Product Change Notification / NTDO-23HTHI228

CCB 6113 Initial Notice: Qualification of MTAI as an additional assembly site for MCP6031T-E/OT, MCP6051T-E/OT, MCP6061T-E/OT and MCP6071T-E/OT catalog part numbers (CPN) available in 5L SOT-23 package.

CCB#: 6113
Pre and Post Change Summary
PCN #: NTDO-23HTHI228

Lead Frame Comparison

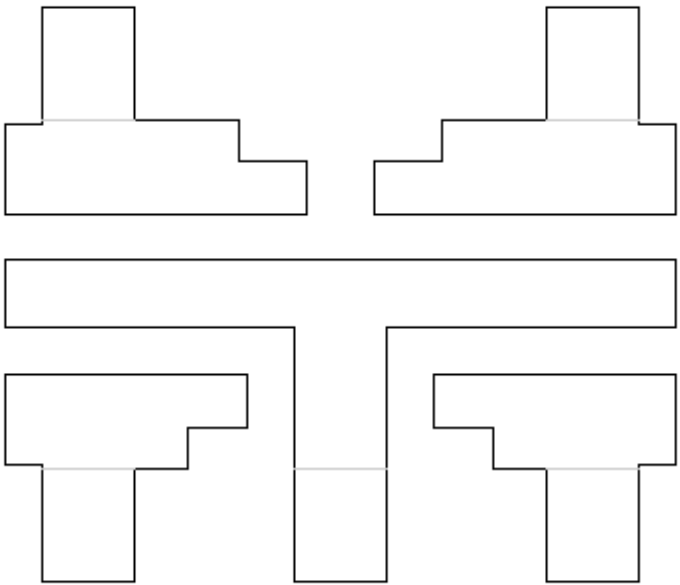
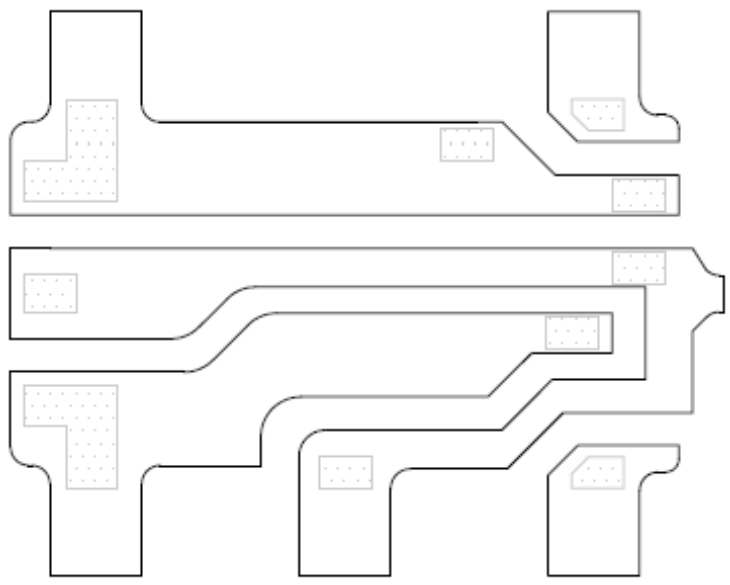
NSEB		MTAI	
 <p>The NSEB diagrams show three lead frame configurations. The top two are simple leaded packages with four leads each. The bottom one is a more complex package with eight leads. All are shown as clean outlines without surface treatments.</p>		 <p>The MTAI diagrams show three lead frame configurations. The top one is a simple leaded package with four leads, showing a stippled surface treatment on the leads. The middle one is a more complex package with eight leads, also showing stippled surface treatment. The bottom one is a similar complex package with eight leads, showing stippled surface treatment.</p>	
Material*	C194	Material*	CDA194
DAP Surface Prep	Ag	DAP Surface Prep	Ag-selective
Treatment	No	Treatment	Roughening
